Enclosure 3 to Long Mott Energy, LLC, Letter No. 2025-PLM-NRC-013

PSAR Subsection 2.4.4, "Potential Dam Failures"

**Long Mott Generating Station
Preliminary Safety Analysis Report**

SUBSECTION 2.4.4 POTENTIAL DAM FAILURES

Figure 2.4.4-2
Model Cross Section at Canyon Dam

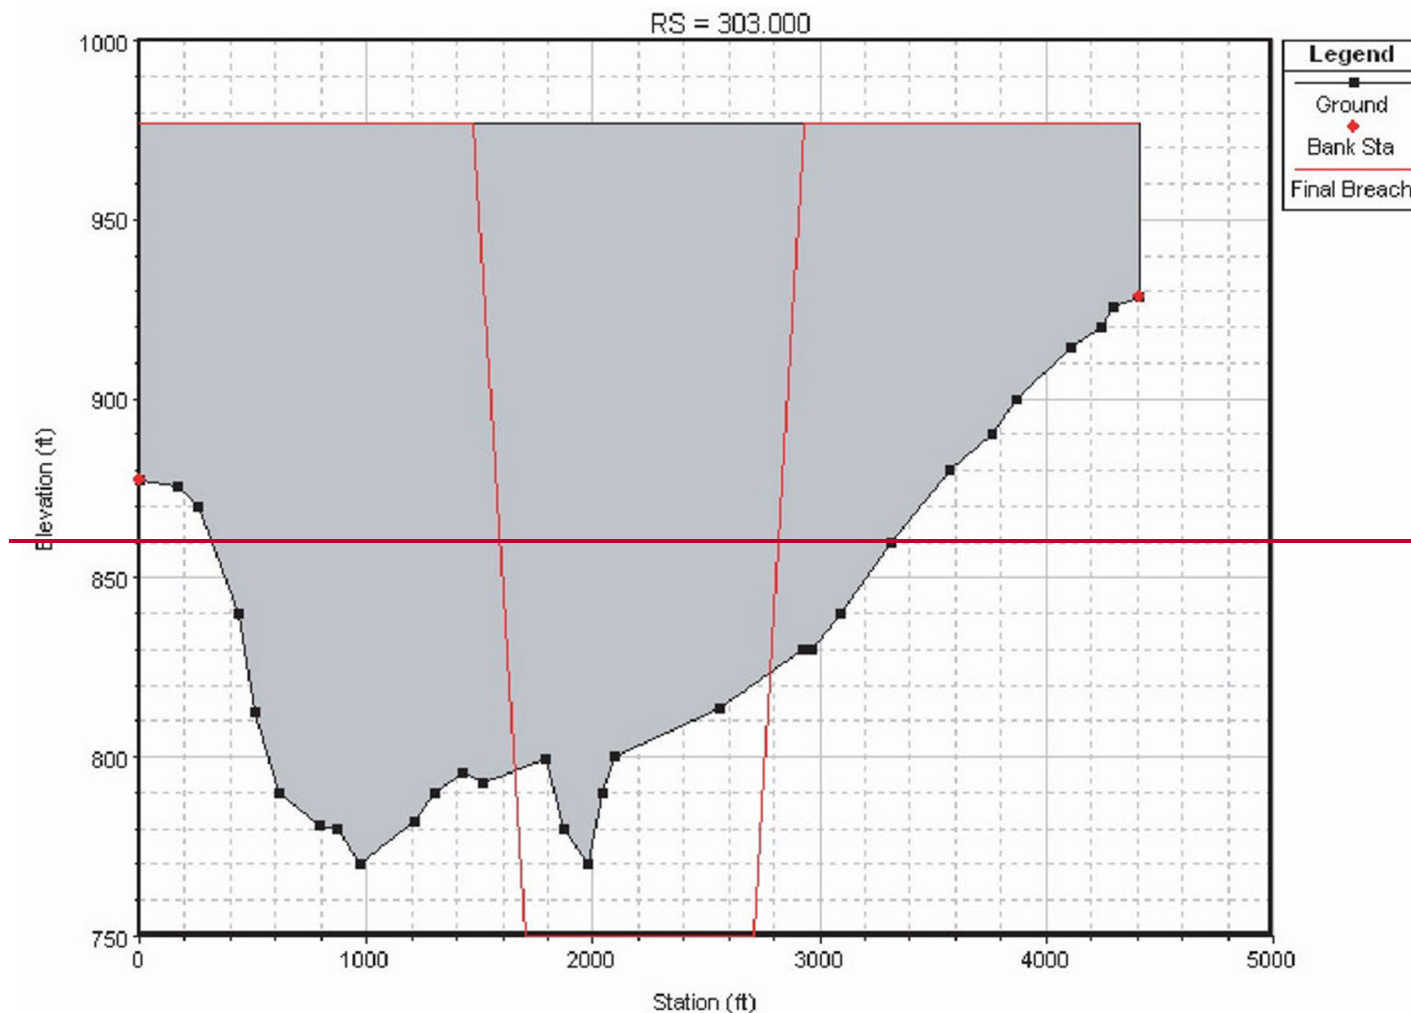
~~Canyon Dam is an earth dam, located about 270 river mi. (435 km) upstream of the LMGS site, is 6830 ft (2082 m) long and 219 ft (66.8 m) high. Following the guidelines from the Federal Energy Regulatory Commission (FERC) on dam break analysis (FERC, 1993), five times the dam height (1120 ft or 341.4 m) is assumed to be the average breach width in the simulation. The breach section in the model was represented by a 1:1 side slope with bottom and top widths of 896 ft (273 m) and 1344 ft (410 m), respectively. The time to complete the breach was assumed to be 0.1 hr, based on guidelines from the FERC for the estimation of the dam breach parameter (FERC, 1993). The model cross section for Canyon Dam is shown in Figure 2.4.4-2.~~

Figure 2.4.4-2
Dam Failure & 500-Year Elliptical Storm with Outfall Gage Junction at Cuero

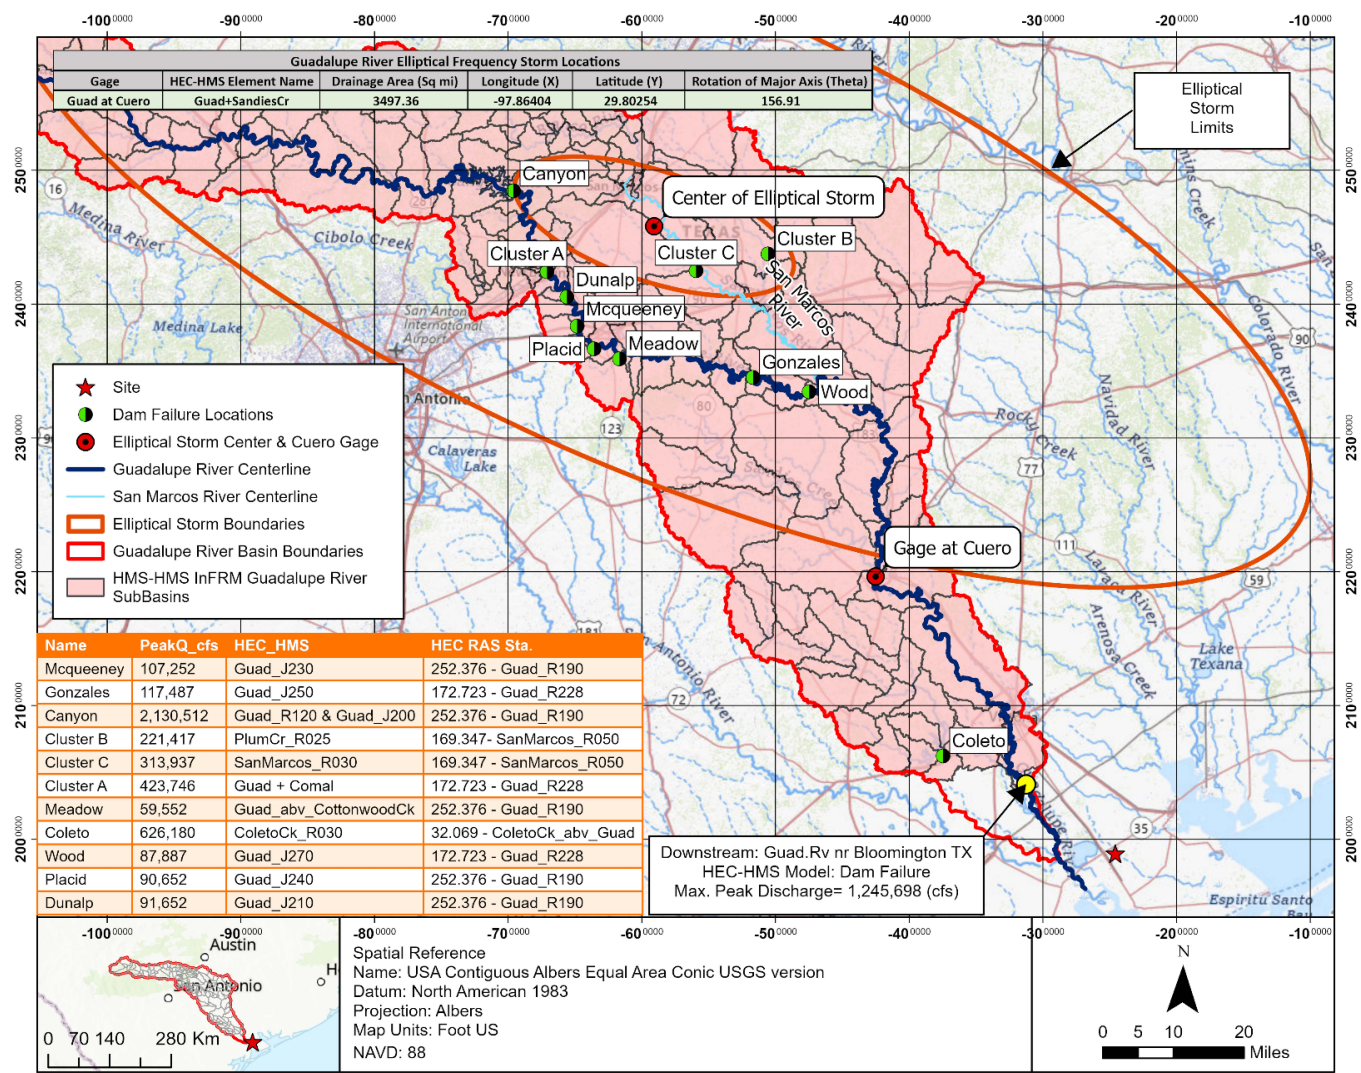
simulations in HEC-HMS were performed for 60 junctions. The model was then simplified to include only one setup configuration for ease of use. The elliptical storms used the same point rainfall tables and durations as the uniform rainfall method from the NOAA Atlas 14, Volume 11. The point precipitation values that were applied to each elliptical storm were based on the storm center's locations, not the location of the gage outlet of interest. The center point location and the rotation of the major axis for seven gages was used to determine the highest peak for the 500-year storm event. The elliptical storms used a maximum storm extent of 10,000 mi², and an elliptical ratio of 3:1. A sensitivity analysis was conducted to determine the gage that produced the largest discharge for the 500-year storm event and covered majority of the lower Guadalupe River Basin. It was determined that rainfall at the Cuero gage produced the highest peak discharge of 773,141 cfs (21893 cms) when compared at the outfall of the model near Bloomington, Texas, shown in Figure 2.4.4-2.

Eleven dam breach hydrographs were incorporated into the dam failure HEC-RAS model to represent various failure points along the Guadalupe River Basin. The dam failure points used in HEC-RAS are shown in Figure 2.4.4-2. These hydrographs were strategically placed at key upstream locations throughout the basin. The eleven hydrographs were arranged into two simulation cases with the 500-year frequency elliptical storm event. The dam breach hydrograph inflow locations were at station 252.376, 172.727, 169.347, or 32.069 for both simulations. For simulation 1, system dam breach hydrographs were added at the following respective stations: station 252.376 for Canyon, Dunlap, McQueeney, Placid, and Meadow dams; station 172.727 for Gonzales and Wood Dams; and station 32.069 for Coletto Dam. For simulation 2, non-system dam breach hydrographs were added at the following respective stations: station 252.376 for cluster A hypothetical dam; and station 169.347 for clusters B and C hypothetical dams. The dam failure hydrographs inputted for cases 1 and 2 are shown in Figures 2.4.4-4 and 2.4.4-5, respectively.

Figure 2.4.4-3
Model Cross Section at Coleta Creek Dam

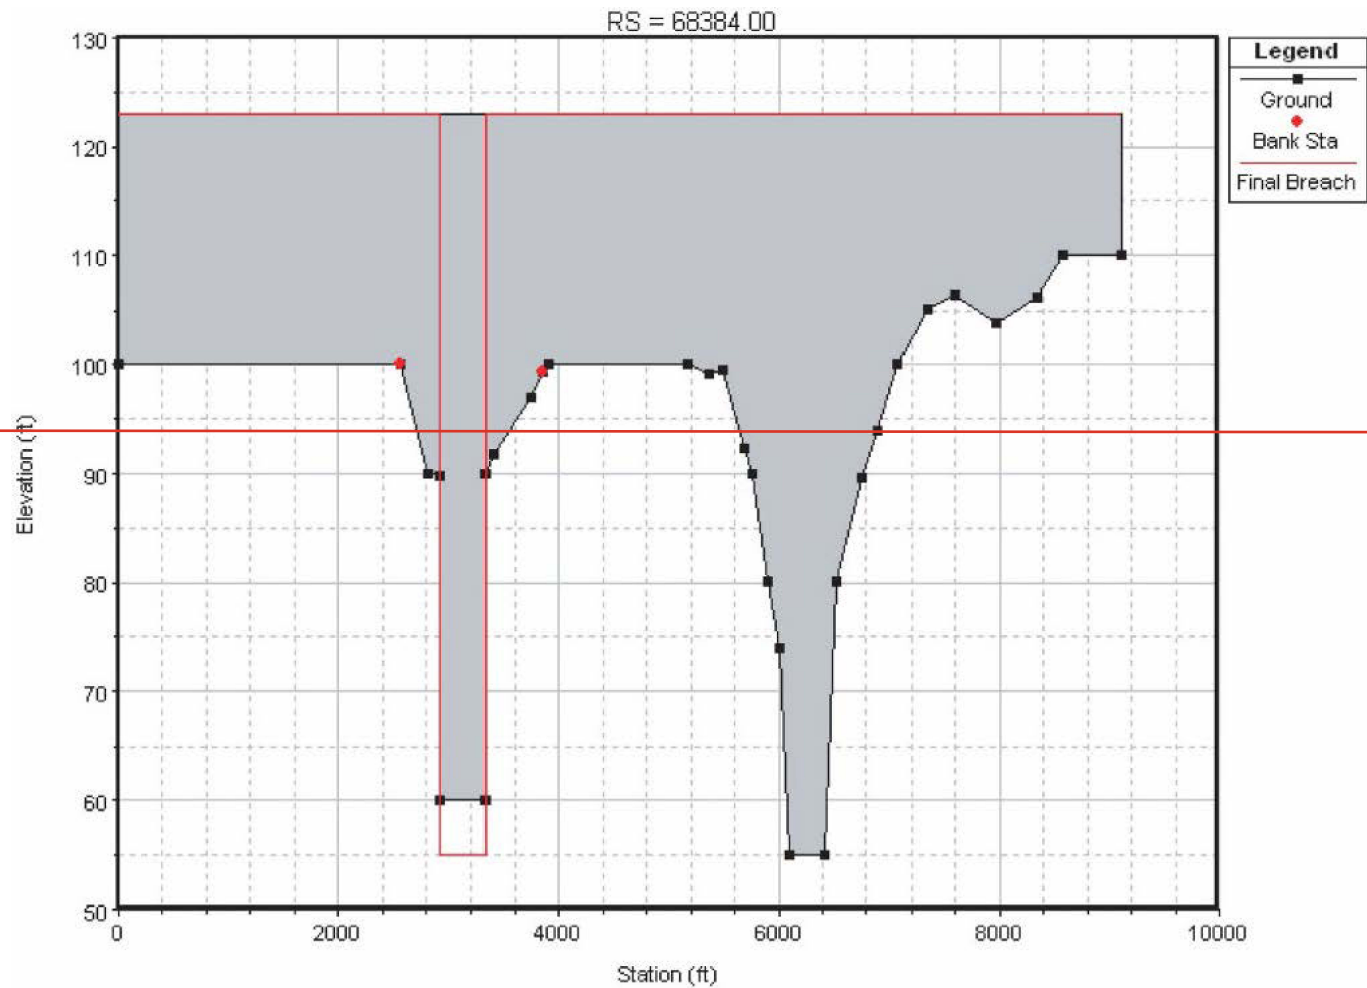
~~Coleta Creek Dam, an earth dam 18,950 ft (5776 m) long and 65 ft (19.8 m) high, is located about 46 river mi. (74 km) upstream of the LMGS site. The concrete spillway structure has a gross width of 328 ft (100.0 m) and a total width of 408 ft (124 m), including the extensions on both sides into the earthen embankment. Following the FERC guidelines (FERC, 1993), the entire spillway concrete structure is postulated to fail. This is greater than five times the dam height that would fail along the earthen embankment (325 ft or 99 m). The time to complete the breach was also assumed to be 0.1 hr. The model cross section for Coleta Creek Dam is shown in Figure 2.4.4-3.~~

Figure 2.4.4-12
HEC-RAS 2D Sedimentation Region

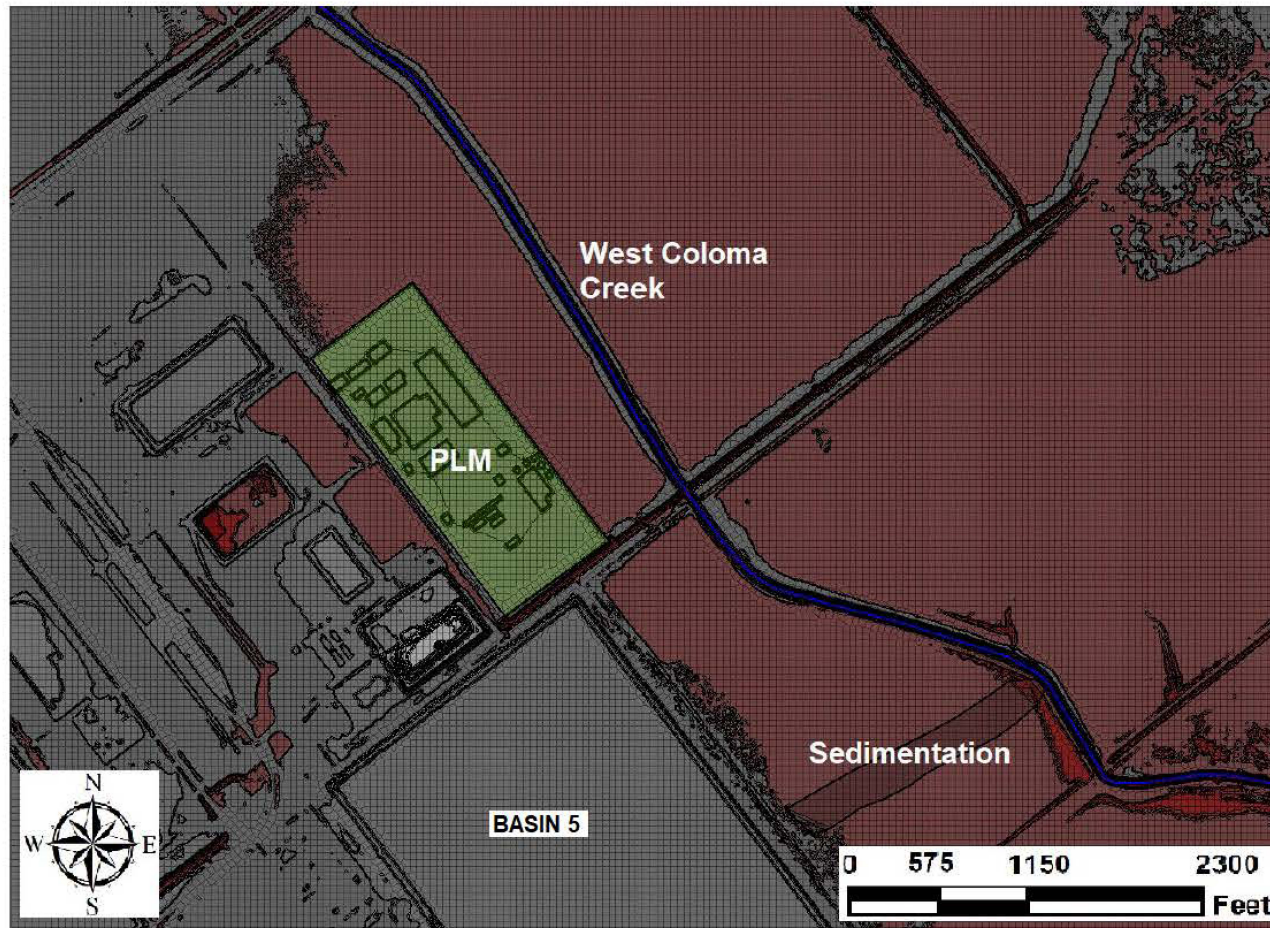
A velocity of 1 ft/s (0.31 m/s) was considered as the threshold and the area shown in Figure 2.4.4-12 was identified as the proper sedimentation region for sensitivity run. This area is on the west side of Coloma Creek floodplain and about 2000 ft (609.6 m) south of the site. Conservatively, the entire floodplain is raised by 2 ft (0.61 m) to simulate blockage by sedimentation. Both scenarios are then run with this modified grade to evaluate the impact on the site. It should be noted that this consideration is conservative as there are incised basins on the west side of the site that can capture the majority of the scouring as deposition inside them in case of any basin failure.

Figure 2.4.4-13
Pond Breach Scenario 1 – Overall Inundation Depth

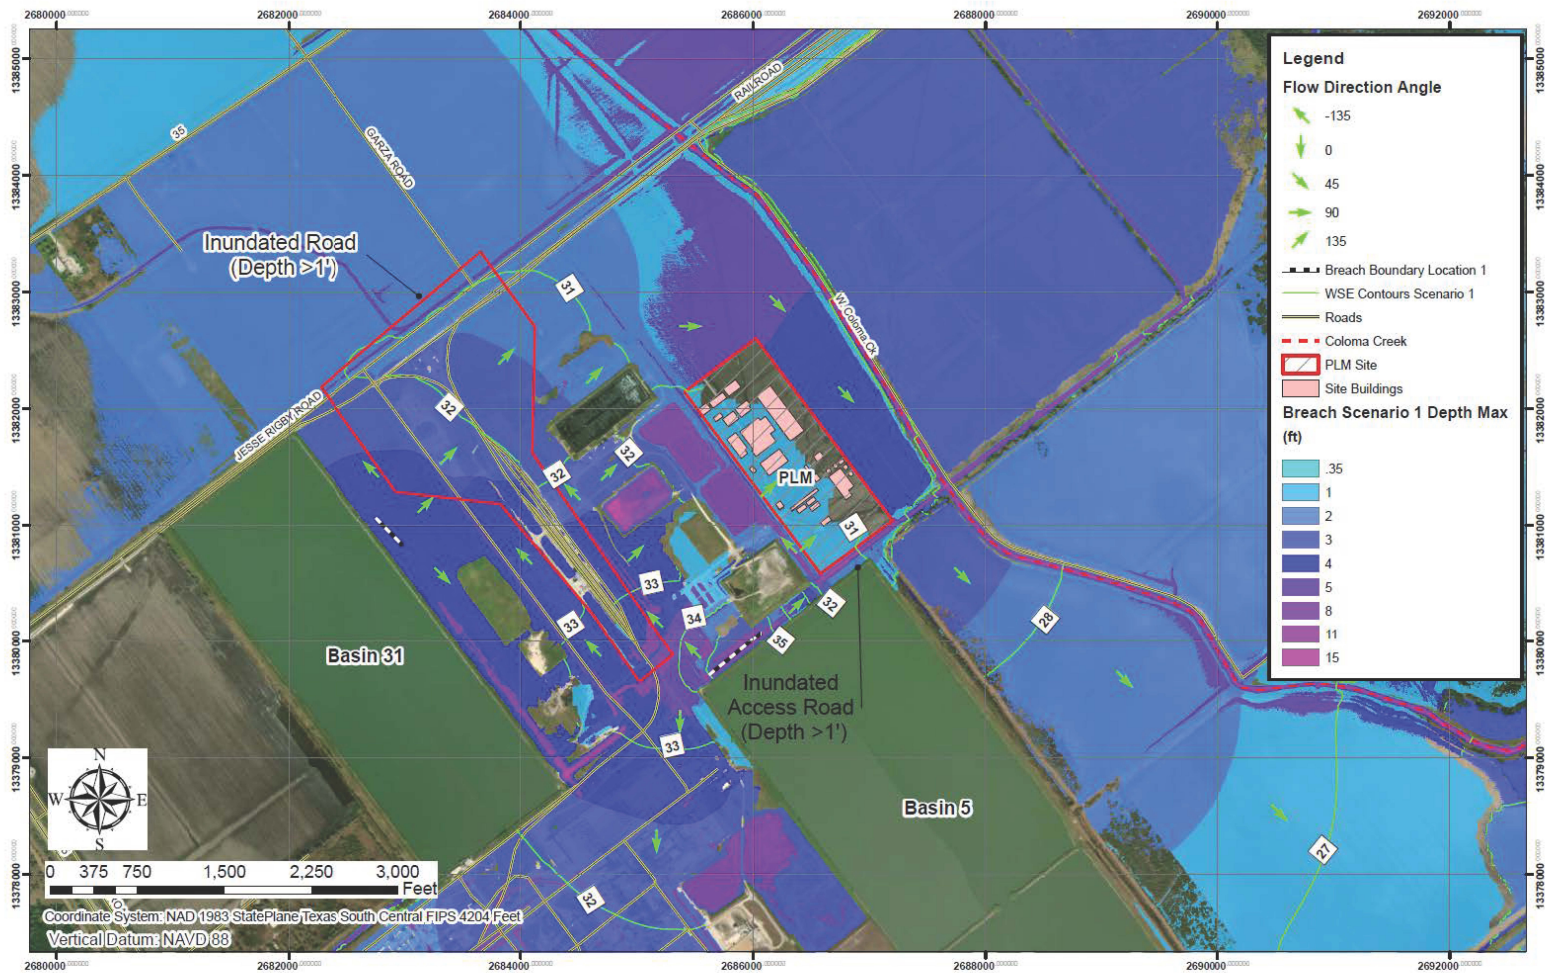
Roads that are inundated by more than 1 ft (0.31 m) are identified for both scenarios (see Figure 2.4.4-13 and Figure 2.4.4-17).

Figure 2.4.4-15
Pond Breach Scenario 1 – Flood Depth at the Long Mott Generating Station Site

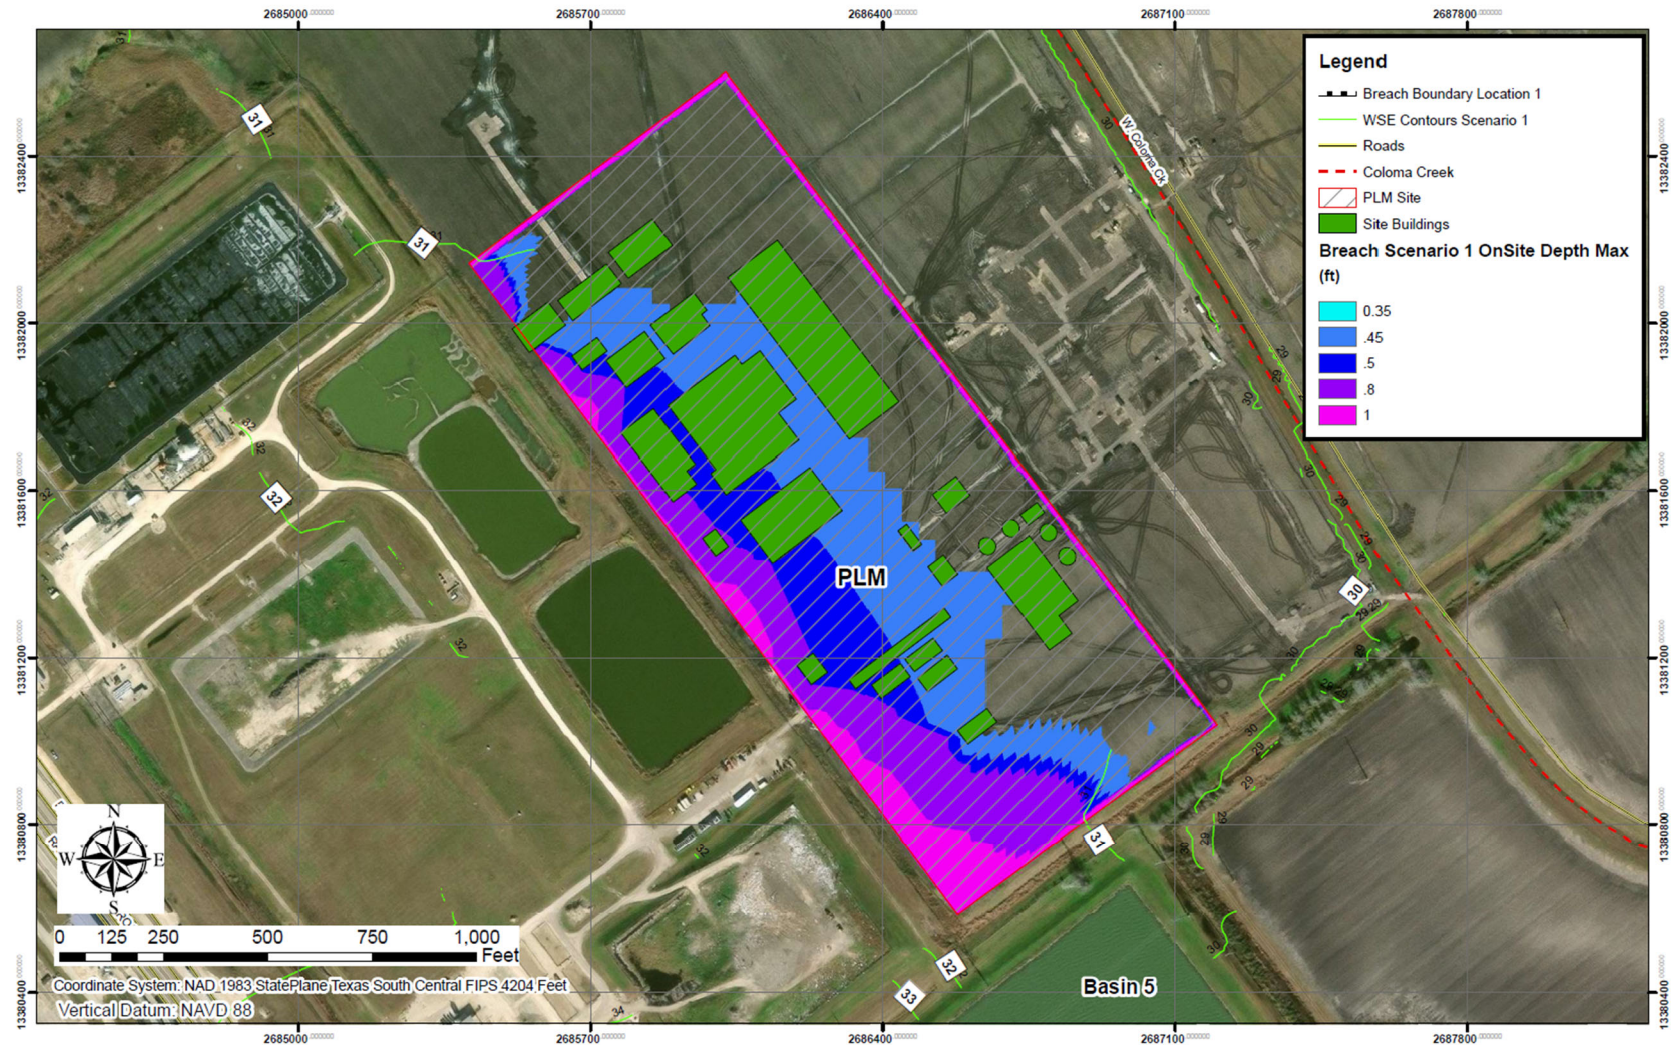
Modeling results are presented in Figure 2.4.4-13 through Figure 2.4.4-20. Under Scenario 1, the maximum inundation at the LMGS site varies from 5 to 10 in. (12.7 to 25.4 cm) with the western edges of the site experiencing flooding depth to the range of 1 ft (2.54 cm) (see Figure 2.4.4-15).
